PRODUCT CHANGE NOTICE

PCN#21-060

Change of plastic substrate

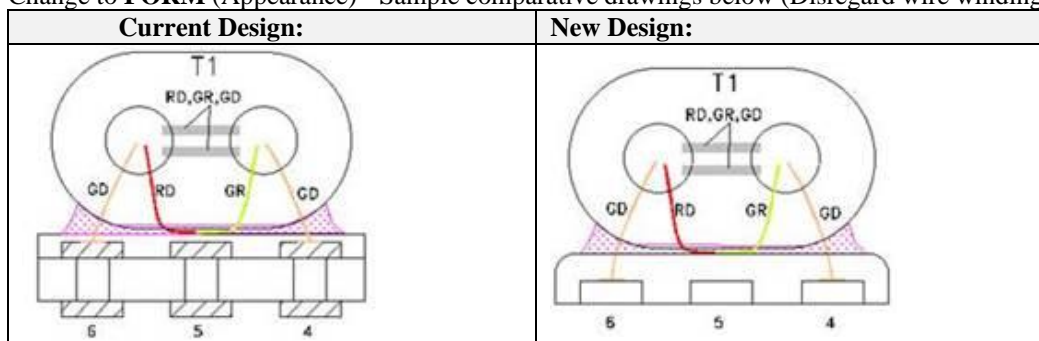
- No change to **Function** (Performance)
- Change to **FIT** (Dimension)– Drop in footprint equivalent, Reduction in total height
- Change to **FORM** (Appearance) - Sample comparative drawings below (Disregard wire windings)
